BUILDINGS ORDINANCE (Chapter 123) (Section 35)

> Superseding Order by the Building Authority under section 24(1) of the Buildings Ordinance (Cap. 123) and under section 46 of the Interpretation and General Clauses Ordinance (Cap. 1)

Order No. : C/TF/001282/23/K : EB/4892/62/T01N BD Ref

12TH FLOOR, WAI YIP HOUSE NO.174 PRINCE EDWARD ROAD WEST KOWLOON

Plan Annexed to Order No.

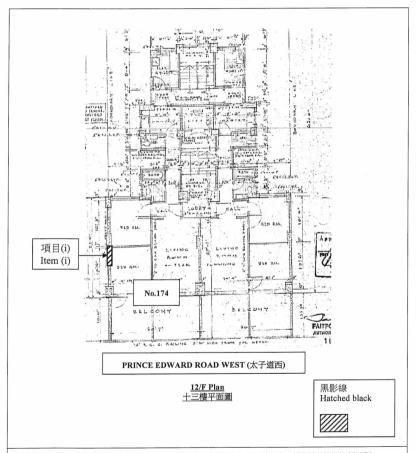
An opening formed in the wall facing No.172 Prince Edward Road West Kowloon.

- For the said building works:
 - As a result of the building works at item (i) above, Section 35 of the Building (Construction) Regulation, which requires the building to be designed and constructed so as to, in case of fire, inhibit or provide adequate resistance to the spread of fire and smoke; and maintain the stability of the building, has been contravened.
- In exercise of the powers vested in me under section 24(1) of the Buildings Ordinance, I hereby order you
 - reinstate the parts of the building so affected by the building works under item (i) above in accordance with the *plans approved by the Building Authority/ minor works completion record submitted to the Building Authority.

- You are required to commence the works ordered by me in paragraph 3 above within 30 days and complete such works within 60 days of the date of this order, all to the satisfaction of the Building Authority.
- 5. Section 46 of the Interpretation and General Clauses Ordinance (Cap. 1) provides, inter alia, that where any Ordinance confers power upon any person to make any order, such power stall include power to substitute another order for the one literally made. Pursuant to that section, the Building Authority who is empowered under section 24(1). of the Buildings Ordinance (Cap. 123) to make the previous order i.e. Order No. C/TF/004072/11/K dated 1 February 2012 is also empowered to make this order which substitutes the previous order.
